PUBLIC INTEREST REVIEW FOR GROUND WATER APPLICATIONS

SUBJECT: Application G- 16605 Supersedes review of N/A

A. GENERAL INFORMATION: Applicant's Name: Herb Davis County: Harney

G-16605
HARN
50673
el 4108

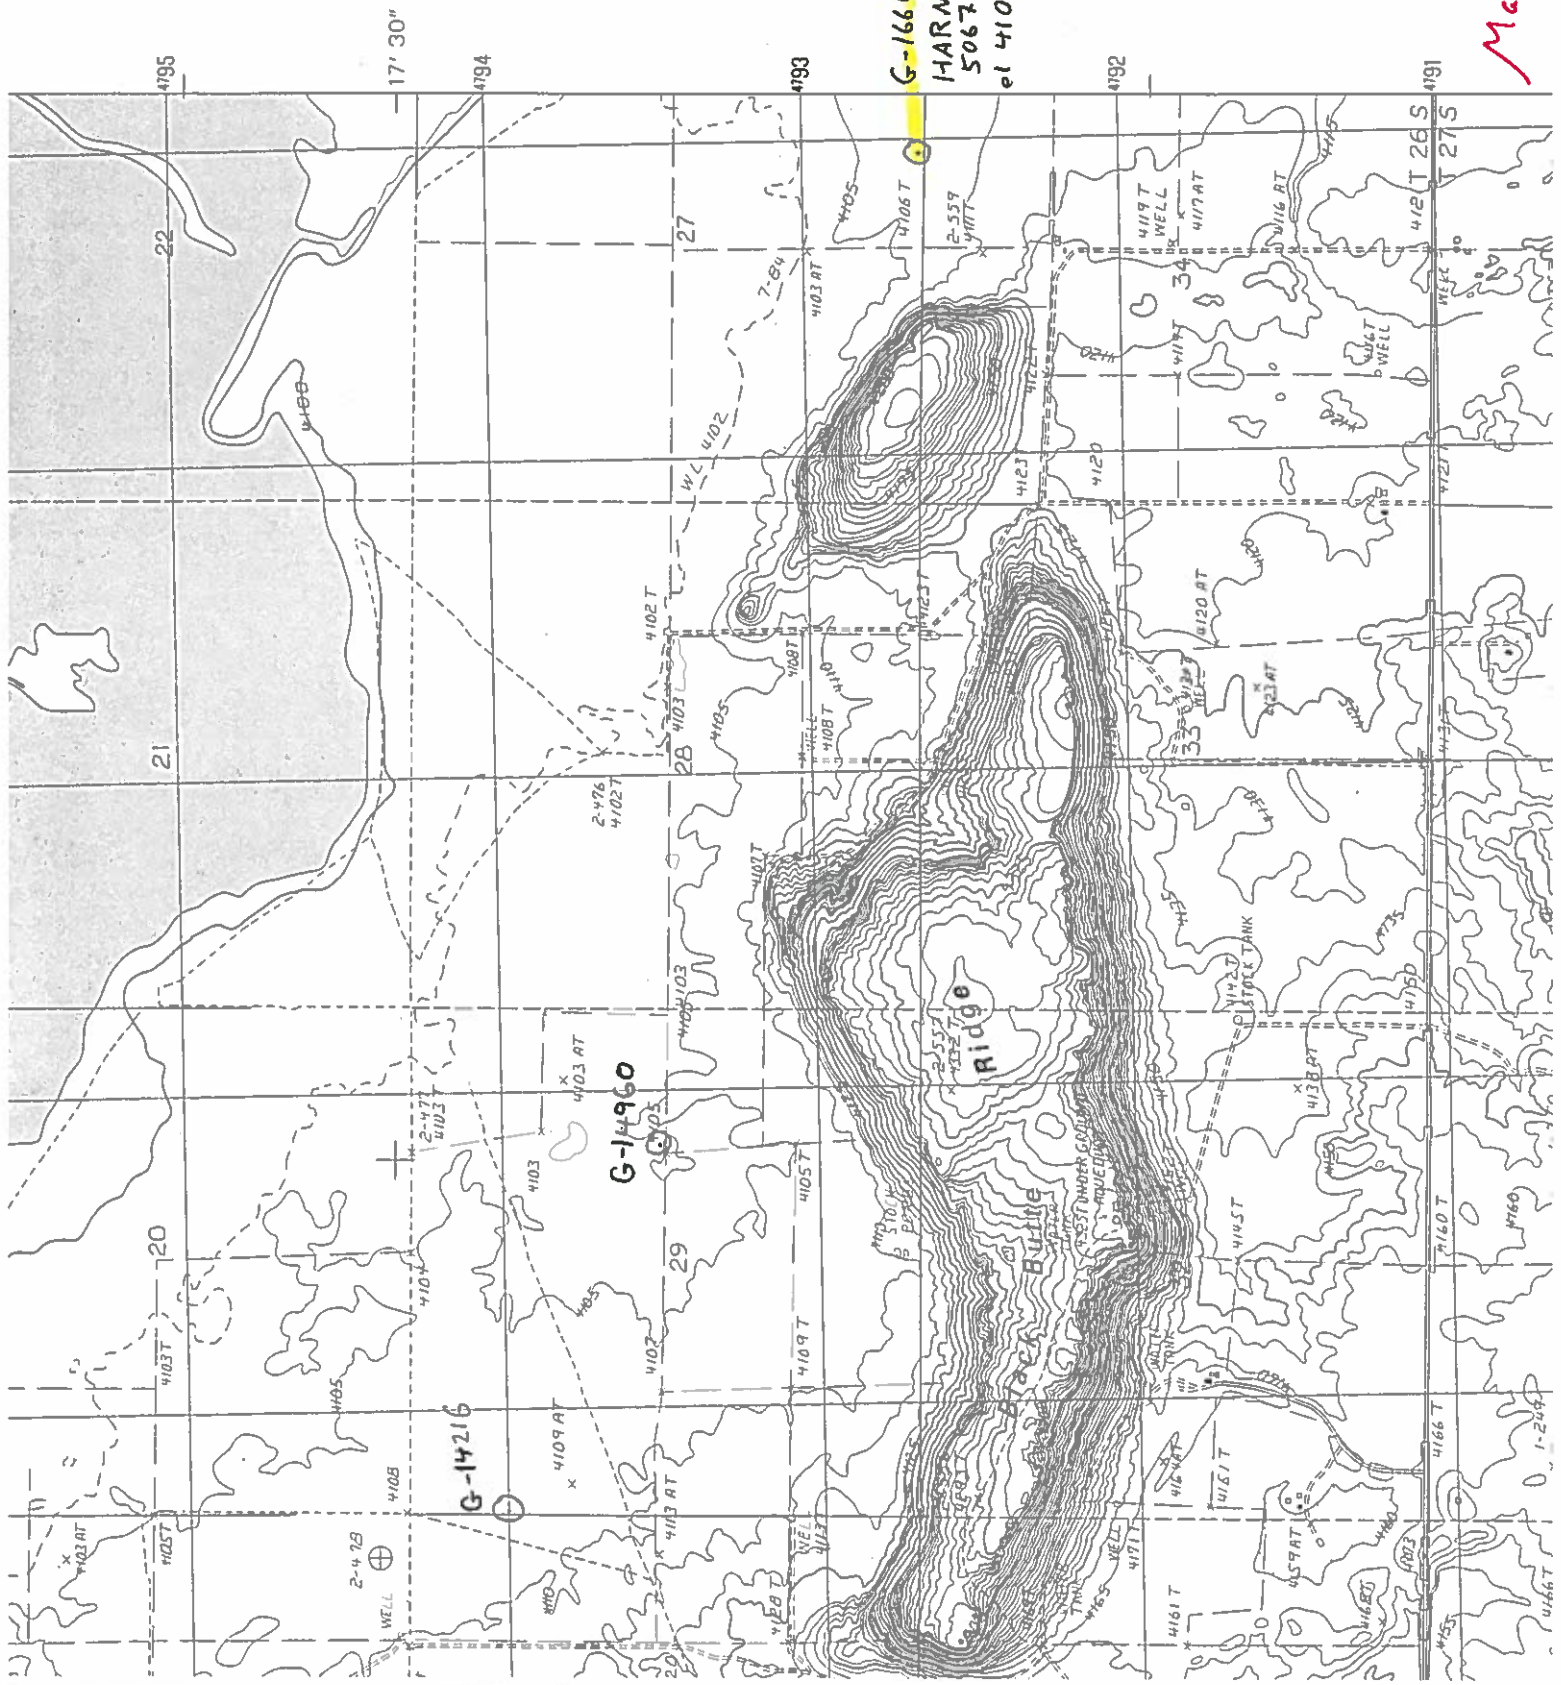
Basis for aquifer hydraulic connection evaluation: *Both the surface water elevation and distance to the well will vary as the lake level changes. Currently, the lake is more distant than shown on the quadrangle map. It is very likely that the aquifer penetrated by the well ultimately discharges to Malheur Lake.
